UNITED STATES PATENT AND TRADEMARK OFFICE

APPLICATION NO.	FILING DATE	FIRST NAMED INVENTOR	ATTORNEY DOCKET NO.	CONFIRMATION NO.
10/782,507	02/19/2004	Shinichi Kurita	007957 Display/AHRDWRE	4717
41161	7590	02/09/2006		EXAMINER TRAN, KHOI H
DUGAN & DUGAN, PC 55 SOUTH BROADWAY TARRYTOWN, NY 10591			ART UNIT 3651	PAPER NUMBER

Office Action Summary	Application No.	Applicant(s)
	10/782,507	KURITA ET AL.
	Examiner Khoi H. Tran	Art Unit 3651

DETAILED ACTION

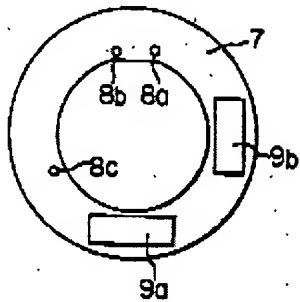
4. Claims 1-7 are rejected under 35 U.S.C. 102(b) as being anticipated by Sato et al. 4,407,627.

Sato et al. '627 disclose a substrate positioning system per claimed invention.

The system comprises plurality of pushing devices 9a/9b and plurality of stops 8a/8b/8c arranged in spaced relation around a stage (see figure on the next page). Pushers 9a/9b are arranged perpendicular from one another. The system comprises an inherent

controller coupled to each pushing device to cause the pushers to push the substrate against the stops 8a/8b/8c.

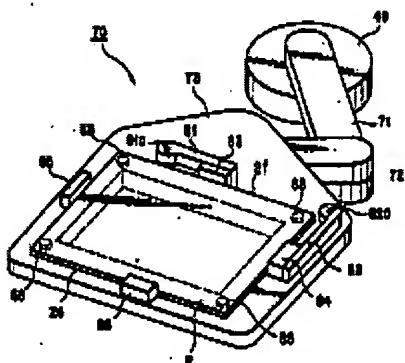
5. Claims 1-7 are rejected under 35 U.S.C. 102(b) as being anticipated by Hikori et al. 5,374,147.

Hikori et al. '147 disclose a substrate positioning system per claimed invention. The system comprises plurality of pushing devices 81/82 and plurality of stops 85/86 arranged in spaced relation around a stage (see figure below). Pushers 81/82 are arranged perpendicular from one another. The system comprises a controller coupled to each pushing device to cause the pushers to push the substrate against the stops.

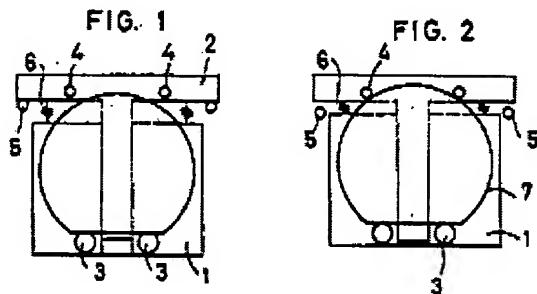
6. Claims 1-6 and 9-10 are rejected under 35 U.S.C. 102(b) as being anticipated by Mutoh 5,484,252.

Mutoh '252 discloses a substrate positioning system per claimed invention. The system comprises plurality of pushing devices 4 and plurality of stops 3 arranged in spaced relation around a stage (see figure below). Each pusher comprises a spring 6 for biasing the pusher toward the edge of the substrate. Each pusher comprises a retracting device 14 adapted to counteract the spring. The system comprises an inherent controller coupled to each pushing device to cause the pushers to push the substrate against the stops.

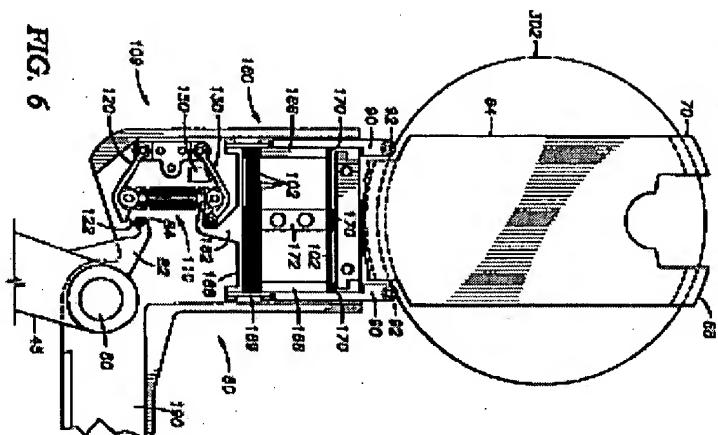
7. Claims 1-6 and 9-10 are rejected under 35 U.S.C. 102(b) as being anticipated by Ebbing et al. 6,155,773.

Ebbing et al. '773 disclose a substrate positioning system per claimed invention. The system comprises plurality of pushing devices 92 and plurality of stops 68/70 arranged in spaced relation around a stage (see figure on the next page). Each pusher comprises a spring 110 for biasing the pusher toward the edge of the substrate. Each pusher comprises a retracting device 82 adapted to counteract the spring. The system comprises a controller coupled to each pushing device to cause the pushers to push the substrate against the stops 68/70.
